UNITED STATES ENVIRONMENTAL
PROTECTION AGENCY
REGION IX
75 Hawthorne Street
San Francisco, CA 94105

STATE OF HAWAII
DEPARTMENT OF HEALTH
P. O. BOX 3378
HONOLULU, HI 96801-3378

Re: Approval to revise schedule for deliverables 6.3- Investigation and Remediation of Releases Report and 7.1.3. - Groundwater Flow Model Report of the Red Hill Administrative Order on Consent ("AOC") Statement of Work ("SOW") and Comments on Interim Environmental Reports

ATTACHMENT 2

Figure 1.1 Estimated Dip Directions in and Around Red Hill

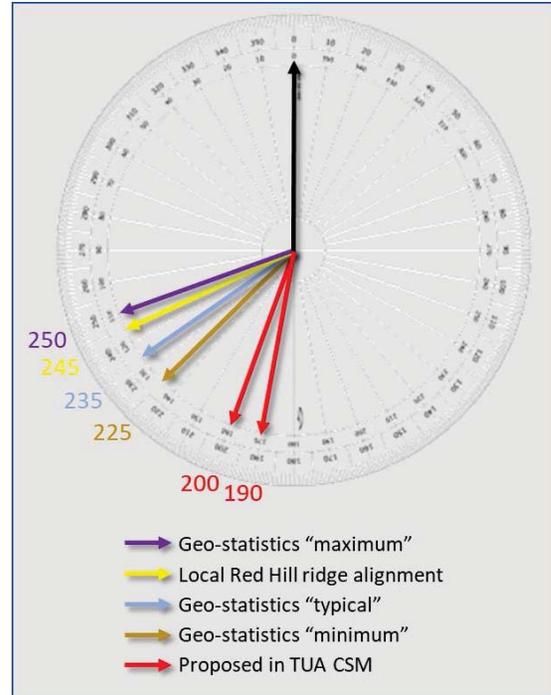
The values for the strike and dip of the lava flows reported by consultants to the Navy (CSM Report, page 5-2: “True dip in the vicinity of Red Hill has been measured at angles of 10–12 degrees, with a strike of 190–205 degrees”) differ from values that were obtained independently by the regulator SMEs via field observation and measurement and geostatistical analysis of barrel log data, which consistently exhibit lower dip values of about 5 degrees and more westerly strike values (Inset Figure 1.1). Although these differences may appear subtle, they are consequential for groundwater flow and potential contaminant transport paths. This is illustrated in Inset Figure 1.2, which presents pathlines calculated using the interim groundwater model, with values for the direction of anisotropy that differ by 10 degrees (particles depicted in red were computed with a more westerly direction of anisotropy reflecting a more westerly assumed dip direction).

Because there is a variety of data sources for dip and strike at Red Hill, it is appropriate to combine the data while considering their representative scales and quality to obtain a best-estimate at the scale of most interest to the fate-and-transport evaluation. Data sources at Red Hill include (a) close-quarters outcrop measurements such as obtained with a compass-clinometer, (b) surveys of visible outcrop from a distance that allow the geometry of a continuous bed-set to be followed for many tens or hundreds of feet, and (c) geostatistical analysis of the barrel log data. The resulting best-estimate derived from combining these lines of evidence can be to some extent corroborated by intersecting the derived plane with a digital elevation model for comparison with features observed in the field (Inset Figure 1.3).

Figure 2.1 Example Comparison of Seismic Profiles and Representation in the Interim Model

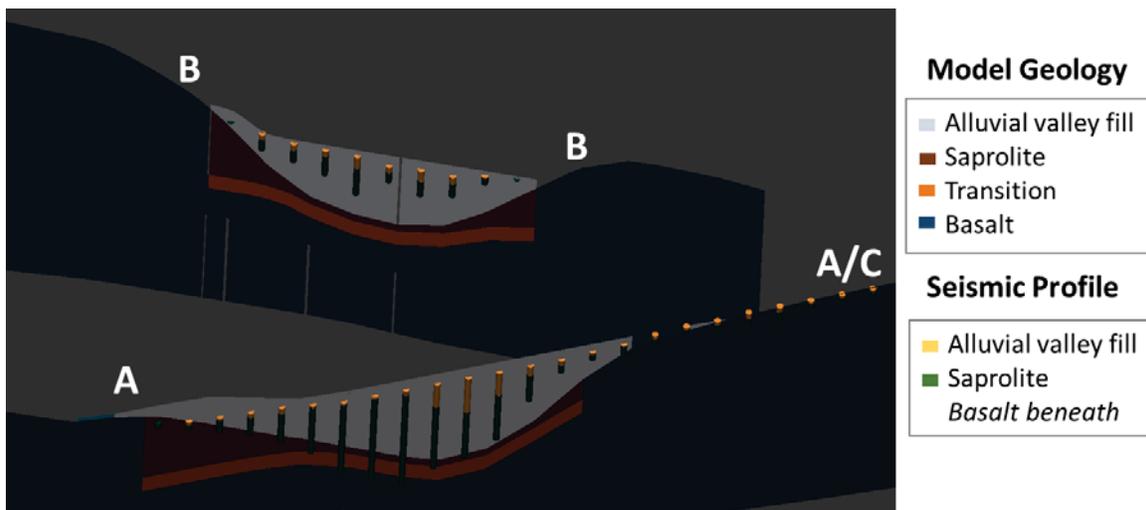
Review of the representation within the interim groundwater flow model files provided for courtesy review by the Navy of the saprolite/basalt interface depths and general trends (i.e., slopes) relative to the axis of the North and South Halawa Valleys suggests the saprolite is likely deeper down-valley and shallower up-valley than represented in the interim model. One consequence is that the point up-valley where the saprolite/basalt interface rises above water table may be more downslope than currently represented. If this is true, the role of the saprolite as a barrier to flow between valleys – particularly in up-slope areas – may be less protective than the current conceptual model indicates (Inset Figure 2.1).

Available data which are overwhelmingly large scale and relatively low resolution (i.e., seismic profiles) must be interpreted in the context of the CSM and AOC to provide an appropriate representation for purposes of the flow and transport modeling. The solution to this problem likely lies in two parts: First, re-interpretation of the available data. When the currently seismic-inferred depths to the saprolite/basalt interface are compared to the CSM, the down-valley transects show a deeper interface depth than the current CSM would suggest while the up-valley transects suggest a shallower interface than currently believed. Interpolating between the down-valley and up-valley transects and extrapolating this trend up-slope from the most up-valley transect may help define where the saprolite is no longer beneath the water table and thus a barrier to flow and transport. Second, ground-truthing of the seismic data using test borings (this may already be planned as there is discussion of a test boring adjacent to Seismic Transect E near the Halawa Deep Monitoring Well [HDMW2253-03]). Additional ground-truthing is highly desirable, even though

costly, in targeted areas with maximal information benefit to provide (a) seismic velocities needed to better constrain the depth to the saprolite/basalt reflector and (b) interface elevations at key boring locations to condition the geophysical results.

Figure 3.1 Example Figure Illustrating Hydrostratigraphic Features

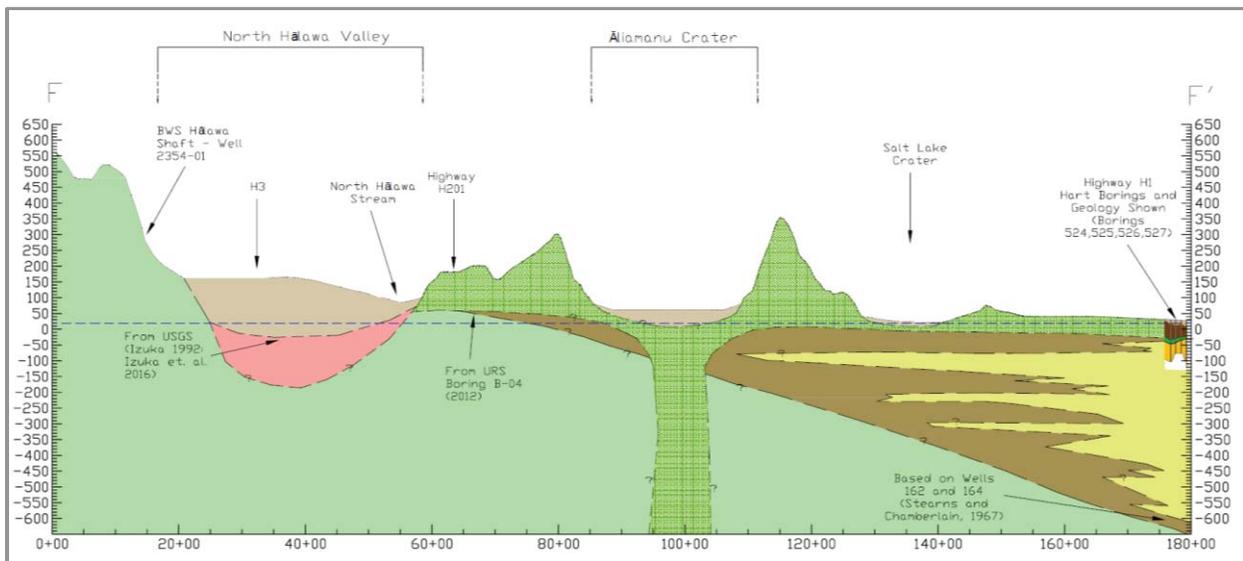
Gradients simulated by the interim flow model, as presented in the GPEC Report and determined from the interim model files provided for courtesy review by the Navy, do not comport well with gradients determined from synoptic data in and around Red Hill facility. While this is in part related to conditions local to Red Hill, analyses conducted using the interim model exhibit high sensitivity to conditions downgradient of Red Hill - specifically, in the area broadly represented by the caprock (GPEC Report Section 5.9). This suggests that although uncertain, because there are insufficient data available to uniquely and accurately specify the distribution and properties of downgradient geologic units, it is important to represent the hydrostratigraphy downgradient of the Red Hill facility as accurately as possible, using as one basis the overarching CSM regarding the distribution and properties of these features (Inset Figure 3.1).

Available information must be interpreted in the context of the CSM and AOC to provide an appropriate representation for flow and transport modeling. The solution to this problem likely lies in two parts: First, re-interpretation of the available data, and expanded use of sensitivity analysis and model calibration to help identify probable geometries and properties, including for example extending the saprolites down-valley, and differentiating Honolulu volcanics from surrounding sediments. Second, based on the anticipated results of sensitivity analyses conducted with this updated representation of

these features, consideration should be given to methods of data collection to better constrain the likely presence, extent and properties of these features. For example, other sources of information and data collection – such as airborne gravity surveys – may provide further evidence for the extents of some of these features.

Figure 5.1 Schematic of Recorded and Simulated Inflows

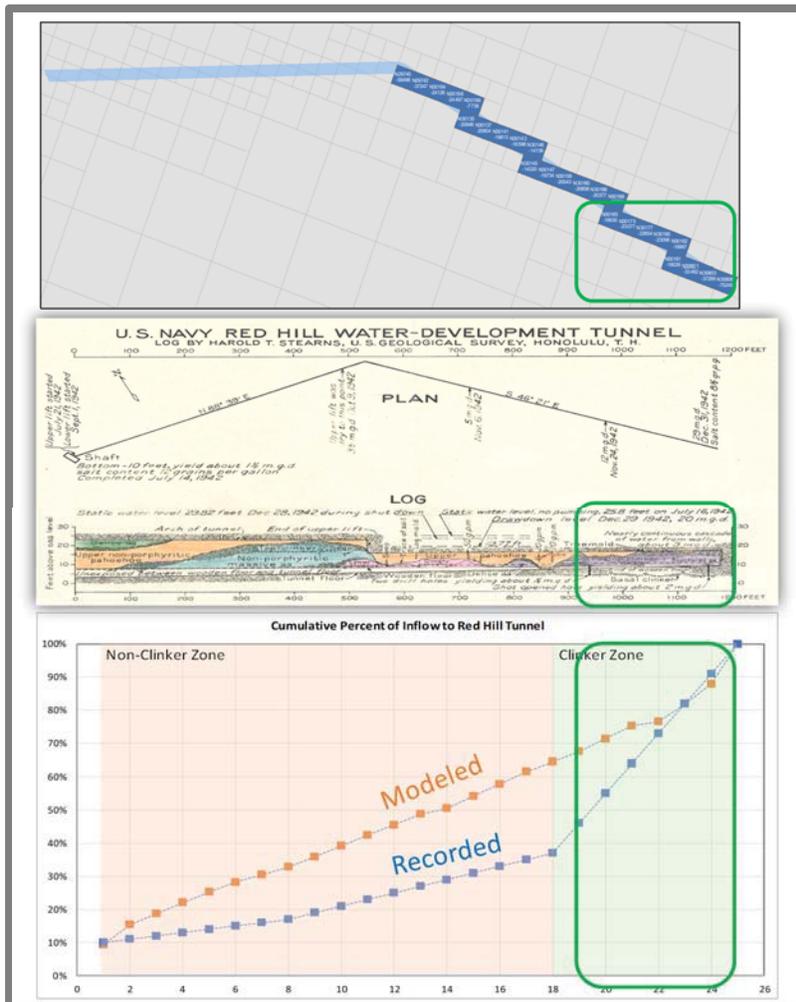
The interim groundwater flow model does represent Red Hill shaft as a linear quasi-horizontal feature rather than at a single vertical point, which is appropriate. However, the distribution of inflows to the eastern tunnel extension simulated by the interim model as determined from the model files provided for courtesy review by the Navy does not appear to match the inflow pattern encountered during tunnel construction (Inset Figure 5.1). During construction, a clinker zone was encountered that contributed more than 60% of the flow to the tunnel whereas the interim model simulates uniform inflow along the tunnel. This difference highlights two issues: first, there is heterogeneity present on a scale of many tens

to hundreds of feet that is not well understood nor represented in the interim model; second, the extent of capture developed by the tunnel may be more head-dependent than represented in the interim model. That is, the capture zone under high water level conditions may be dominated by seepage from this clinker at the end of the east tunnel, but under low water level conditions may be dominated by drawdown within the vertical shaft itself. Sensitivity analyses conducted with the interim model indicate that the model exhibits sensitivity to the potential presence of a clinker zone (GPEC Report Section 5.9).

The final CSM and model should make a greater effort to evaluate the possible role of these heterogeneities – in particular, as an illustrative example, the Red Hill tunnel clinker – on calibration, zones of contribution, and contaminant transport. This may be accomplished for example by evaluating the zone of contribution under high water level conditions dominated by tunnel seepage, and under low water level conditions dominated by active pumping at the Red Hill shaft.

Figure 6.1 Example Comparison of Pairwise Head Differences from Synoptic Data with Simulate Head Differences from All Interim Models

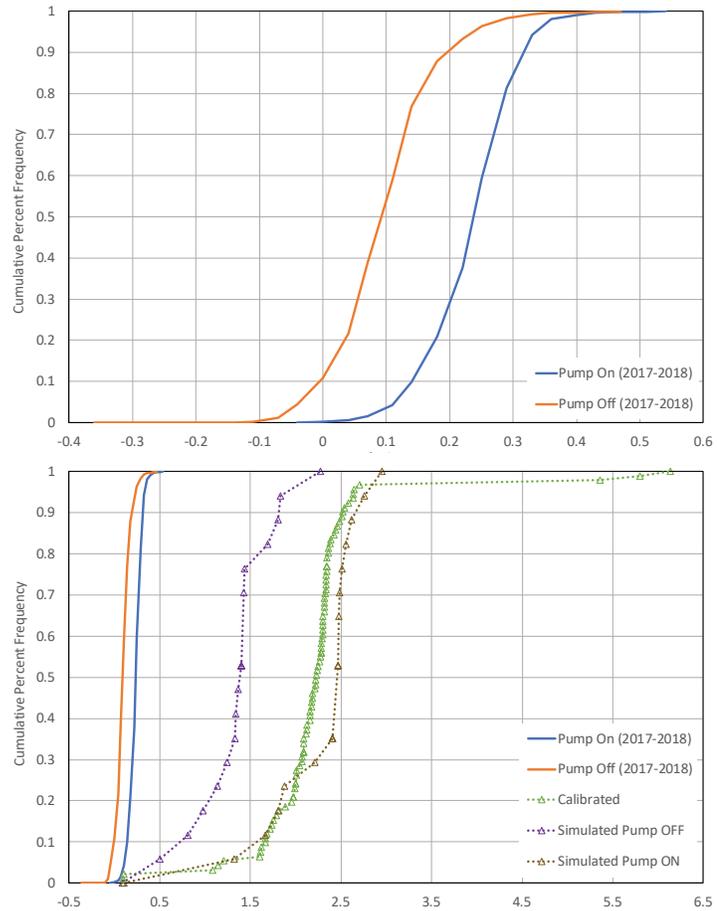
Hydraulic gradients determined from measured data are generally flat in and around Red Hill. On most occasions, gradients are to the southwest at a low slope, but occasionally they appear to be to the northwest and possibly north. The interim model outputs presented in the GPEC Report do not closely reproduce the magnitude or direction of these gradients. Flow in the calibrated interim model is dominantly Mauka-to-Makai, and most of the sensitivity-derived alternative models demonstrate flow toward Red Hill shaft at gradients that are 10 to 100 times higher than measured values. Although the sensitivity analyses do present a range of simulated gradients (GPEC Report Section 5.9), the distribution of simulated gradients across all models that were provided for courtesy review by the Navy does not match closely values derived from the synoptic data (Inset Figure 6.1).

The final CSM and model should focus on analyzing recent high-quality synoptic data to the extent possible, and down-weight analyses based on older data. Despite difficulties preparing water level maps, pairwise head-difference plots can show the effects of pumping on gradients and the frequency and magnitude of gradient reversals. Steady-state model calibration should focus on demonstrating a match

with regional patterns and with representative local gradients under pumping and non-pumping conditions. This combination is required to demonstrate that the model is useful for near-field transport to understand the available groundwater data, and for developing predictions of capture zones for Red Hill shaft and Halawa shaft to help evaluate risk and mitigating responses or strategies. Transient calibration will provide information on T, S, anisotropy, and possibly on the geometry of features such as the saprolite but is not a substitute for obtaining reasonable mean-centered correspondence to the measured gradients (or pairwise head differences).

Figure 10.1 Example Figure Illustrating Variable Discharge to Pearl Harbor

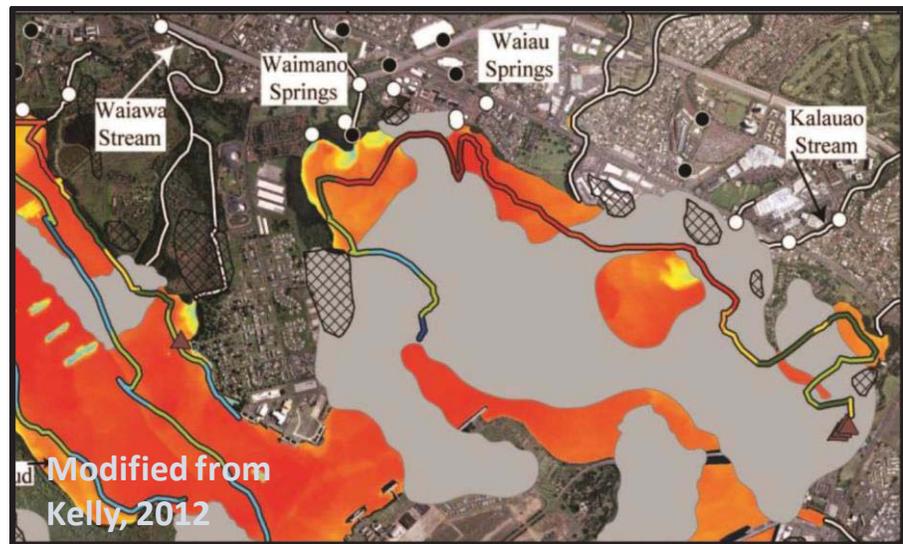
The approach to simulating the groundwater flow to the Pearl Harbor Estuary and the southern offshore regions needs further work. Although uncertain in extent and character, it is important to represent the downgradient outflow conditions as accurately as possible, using as one basis the CSM regarding the distribution and properties of these features, and also other sources of information (Inset Figure 10.1).

The solution likely lies in two parts: First, re-interpretation of the available data, with expanded use of sensitivity analysis and model calibration to help identify probable geometries and properties. Model refinements may include using multiple layers to simulate the caprock and include older alluvial sediments and the muds and tuffs that blanket the floor of Pearl Harbor. Second, based on the anticipated results of sensitivity analyses conducted with this updated representation of these features, consideration should be given to methods of data collection to better constrain the likely presence, extent and properties of these features.

Figure 9.1 Example Terminal Electron Acceptor (TEA) Map – Dissolved Oxygen

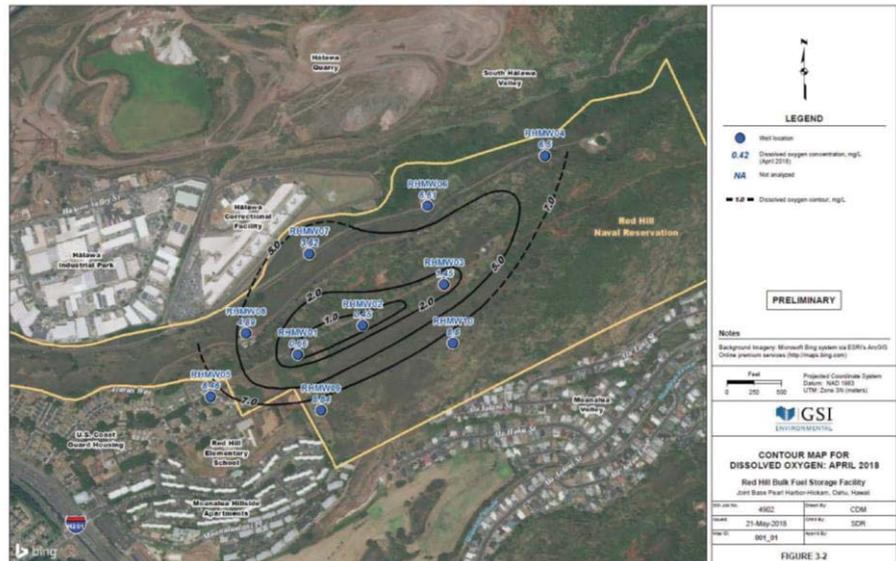
Example 2: Independent analyses of TEA data presented and discussed in CSM Report Section 7.3.2 and Appendix B.4 and GPEC Report Figure 6.3 as indications of natural attenuation (e.g., Inset Figure 9.1), dissolved phase contaminant detection frequency and distribution (inset Figure 9.2), and hydraulic gradients, suggest transport occurred not just to the southwest but also to the northwest and possibly northeast of the facility. Example 3: The distribution and concentrations of general chemistry data (i.e. major ions, specific conductivity, and pH) show a poorly-mixed system inconsistent with the Navy CSM of robust flow from upslope recharge areas to Red Hill Shaft. The chemistry is highly variable with chloride concentrations spanning over an order of magnitude and is more suggestive of sluggish down-slope flow and compartmentalization (inset Figures 9.3 and 9.4).

Before developing the transport model, it is important that the CSM encompass reasonable interpretations of available water quality data. The CSM should, at this stage, allow for “alternative hypotheses” of at least equivalent likelihood of LNAPL impact to groundwater versus the current hypothesis of there having been no impacts. The final groundwater flow model, when it reasonably represents hydraulic gradient directions and magnitudes in the vicinity of Red Hill ridge, would be anticipated to underpin a contaminant transport model that demonstrates a reasonable match historical sample results (contaminants and TEAs, etc.), thereby demonstrating that the model is useful for near-field transport to understand the available groundwater data, and for developing predictions of contaminant transport and fate to help evaluate risk and mitigating responses or strategies.

Figure 9.3 Image of Chloride Concentrations Sampled at Wells

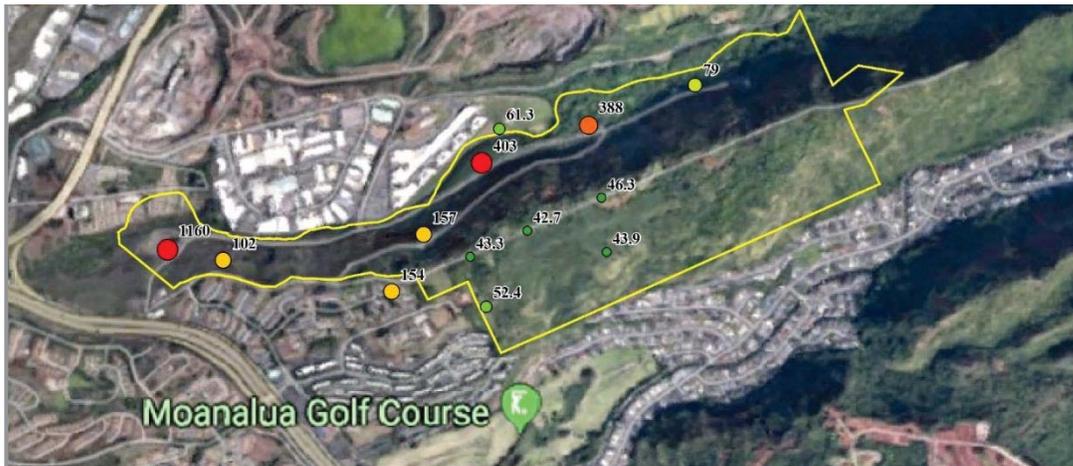
Interpretations of water quality data presented in the CSM Report and GPEC Report are in places non-conservative, and conflict with other lines of evidence and with conclusions reached by regulator SMEs. Example 1: The Navy consultants dismiss some detected results out of concerns for data quality (CSM Report Section 7.2 and Appendix B.7). Though in some instances justified, these concerns do not address all detected results, and from the regulatory perspective, any reported detections that are not qualified are evidence of impacts. Example 2: Independent analyses of TEA data presented and discussed in CSM Report Section 7.3.2 and Appendix B.4 and GPEC Report Figure 6.3 as indications of natural attenuation (e.g., Inset Figure 9.1), dissolved phase contaminant detection frequency and distribution (inset Figure 9.2), and hydraulic gradients, suggest transport occurred not just to the southwest but also to the northwest and possibly northeast of the facility. Example 3: The distribution and concentrations of general chemistry data (i.e. major ions, specific conductivity, and pH) show a poorly-mixed system inconsistent with the Navy CSM of robust flow from upslope recharge areas to Red Hill Shaft. The chemistry is highly variable with chloride concentrations spanning over an order of magnitude and is more suggestive of sluggish down-slope flow and compartmentalization (inset Figures 9.3 and 9.4).

Figure 10.1 Net average temperature greater than the Red Hill Shaft (RHMW2254-01; in degrees Celsius). Like other MNA-related parameters, the elevated temperatures are generally along the Red Hill Ridge and to the west and north. Data source: USGS Synoptic Data, 2018.

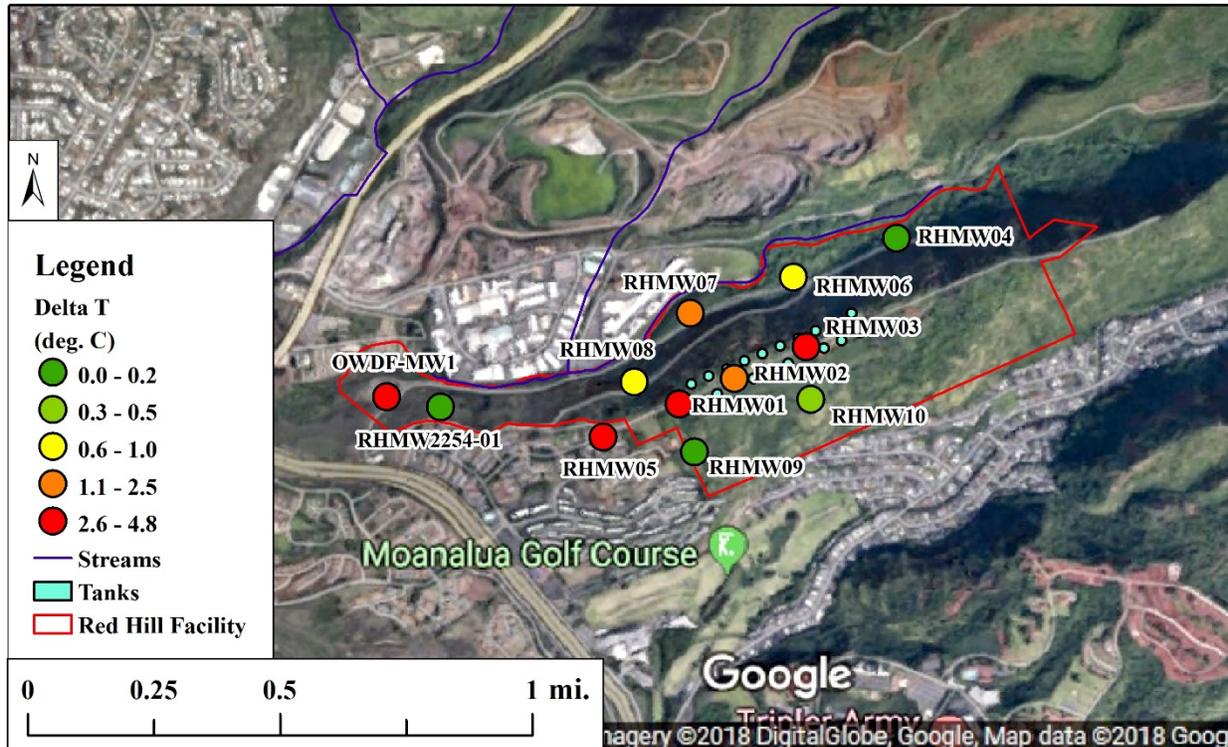
In terms of the depth of migration of LNAPL from the Tank 5 release in 2014, the primary analysis relied upon in the CSM is the thermal profile at RHMW02, with backup support from chemistry considerations. A net positive temperature profile indicates the effects of exothermic biologic reactions and is affected by a variety of subsurface factors. In general, that relationship can be useful to infer lateral distributions of LNAPL biodegradation (e.g., Figure 10.1 above) but is highly uncertain with respect to the LNAPL vertical distribution. In many cases, as shown in the example thermal profile in our August 15, 2018 presentation (Slide 28), the LNAPL vertical mass distribution cannot be inferred from the temperature profile. A review of data in the 2007 Red Hill investigation report (DON, 2007) shows that the rock cores were evaluated for evidence of petroleum contamination by checking for odor and by screening with a photo-ionization detector. No evidence of petroleum contamination was found. The groundwater temperature in RHMW03 measured during sampling has remained unchanged at about 26.5 °C since first sampled in 2005 to the present, indicating that the temperature profile recently measured by the Navy likely existed when RHMW03 was first drilled. As a consequence, this locally-elevated temperature does not directly relate to the migration or distribution of LNAPL arising from the 2014 release but

relates (at least, predominantly) to past releases. Also, there has been no release of consequence since 2005 that would cause LNAPL to enter the zone indicated by the thermal anomaly in RHMW03. In summary, the Navy's contention that the thermal profiles in the tunnel wells show that the LNAPL is constrained above the water table is not supported by the available data. We believe the Navy technical team needs additional data to validate its interpretation of LNAPL transport around Tank 5 from the 2014 release, as it is a fundamental cornerstone to the remainder of the LNAPL F&T considerations. At a minimum, the Navy should include several Hawai'i or equivalent geology examples where the LNAPL source distribution has been definitively interpreted by this method and independently validated through subsurface data demonstrating that actual LNAPL source distribution (e.g., core sampling, downhole investigation, etc.). Alternatively, it would be useful to consider a site specific data collection program to verify the LNAPL source distribution around Tank 5 and possibly other key locations. By whatever approach, additional lines of evidence are needed to verify the assumptions relative to fate and transport of the 2014 release.
